December 11, 2009
Project No. 09-10-23

Re: Response to a TCEQ Notice of Deficiency Letter Dated October 14, 2009, City of Kerrville Landfill, MSW Permit No. 1506A, Kerr County, Texas; WWC 11995264; RN102000551 / CN602452286

This letter is written to provide a response to the comments in a letter dated October 14, 2009, from the Texas Commission on Environmental Quality (TCEQ). The letter requested that the TCEQ comments be addressed within 60 days (December 13, 2009). The TCEQ's comment/questions are provided below in italics with our response immediately following.

PROPOSED GROUNDWATER MONITORING NETWORK

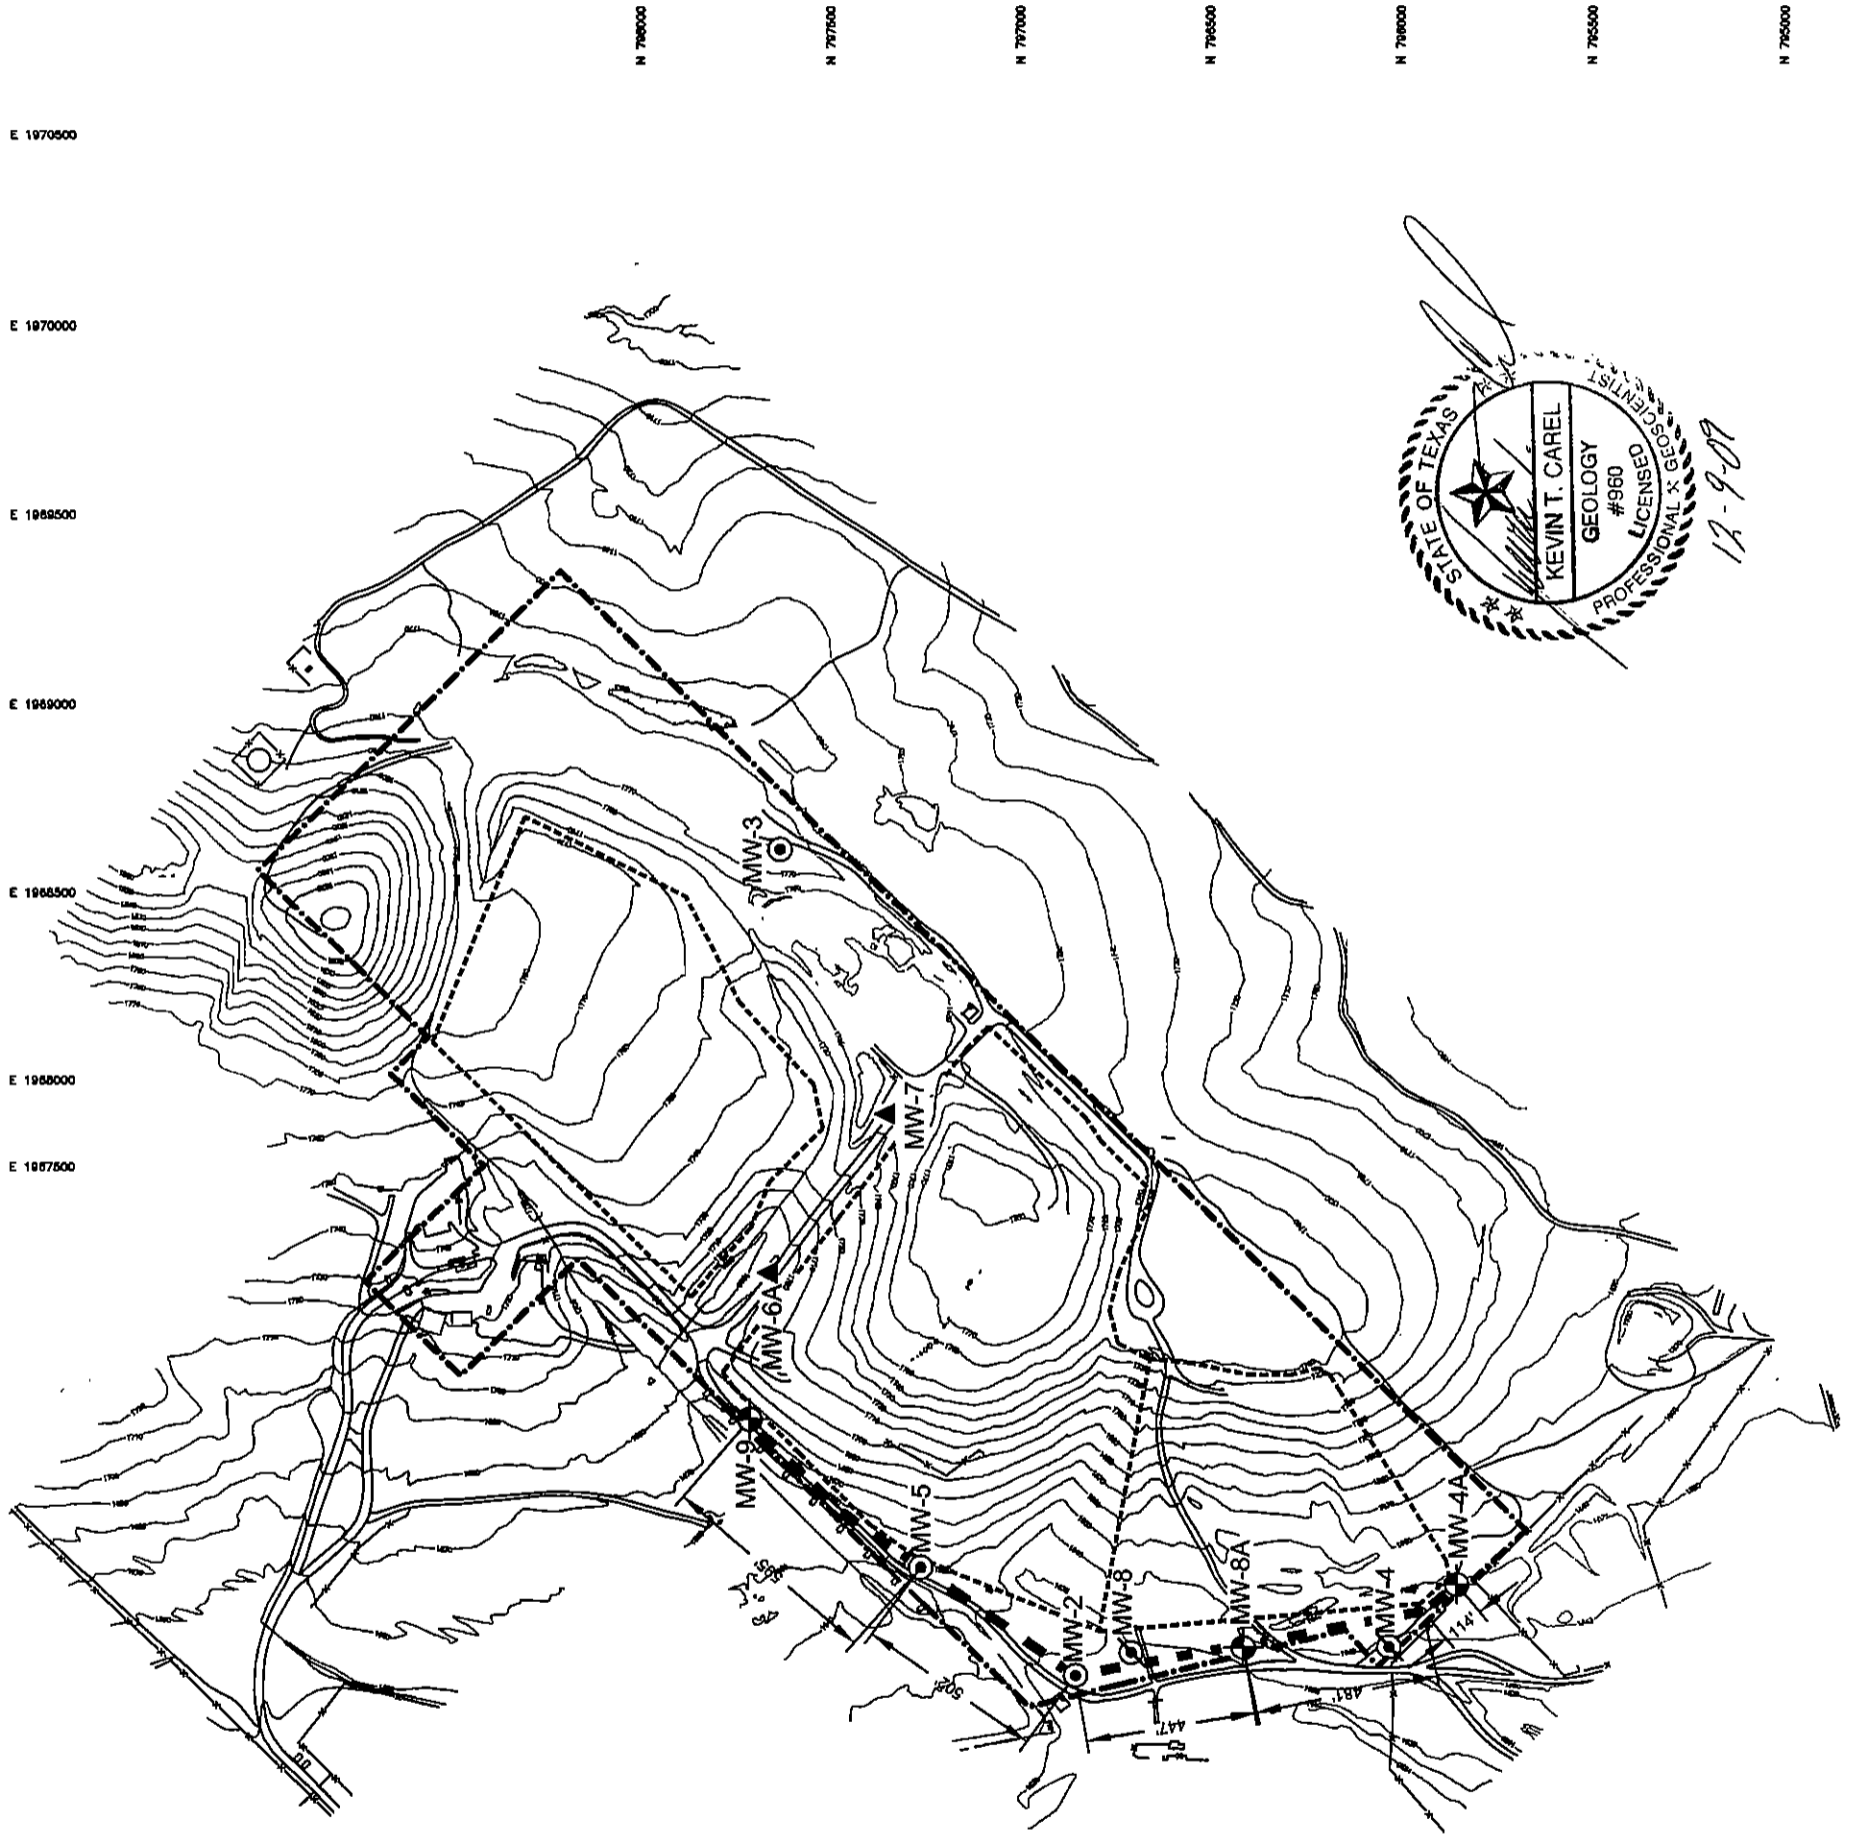
- a. *Please revise the POC to extend along all downgradient edges of the MSW unit, and add monitor wells at the end points of the POC. According to groundwater contour maps in monitoring reports (for example, for the April 2007, April 2008, and April 2009 monitoring events), the edges of the landfill southeast of existing well MW-4 and northeast of proposed well MW-9 are downgradient from waste, and therefore should be included in the POC.*
- b. *Please document the distances between POC monitor wells in the proposed system, as measured along the POC.*

Please retain MW-6A and MW-7 in the monitoring system. Both wells have detected trace to moderate levels of volatile organic compounds, and may be useful in monitoring contaminants or contaminant plumes that may originate from the closed unit, or other sources, and move along flow paths that are within the capture zones of monitor wells downgradient from the active Subtitle D unit.

- Response:
- a. The POC has been revised as requested. MW-4 is proposed to be decommissioned and replaced with MW-4A. MW-4A is located at the end of the POC and will be within 600 feet of the next proposed adjacent well (MW-8A). The location of proposed well MW-9 has been moved northeast of the initially proposed location to the end of the POC and is within 600 feet of existing, adjacent well MW-5.
 - b. Per your request, distances between POC monitor wells have been added to Figure 4-12. The revised figure is provided in Attachment 3 of this response.

Response: The facility will retain MW-6A and MW-7 in the monitoring system as requested. However, given the hydraulic position of MW-6A and MW-7, the facility proposes to retain MW-6A and MW-7 as observation wells only. Water-levels will be collected from MW-6A and MW-7 during routine detection and assessment monitoring events and will be used for hydraulic control. Furthermore, the facility proposes to sample MW-6A and MW-7 on an annual basis, for 40 CFR Part 258, Appendix I volatile organic compounds (VOCs). The text in the permit and Figure 4-12 have been revised to state the above. Both the text and Figure 4-12 are provided in Attachment 3 of this response.

To satisfy the above requirements and based on direction of groundwater flow, it is proposed that ~~two~~ three additional point of compliance groundwater monitoring wells (MW-4A, MW-8A and MW-9) be installed. Additionally, it is proposed to decommission MW-4 MW-7 and MW-8. MW-3 will be designated as the background well for the facility, to allow determination of the quality of back-ground water that has not been affected by leakage from the proposed landfill cells. The proposed groundwater monitoring system is illustrated on Figure 4-12.
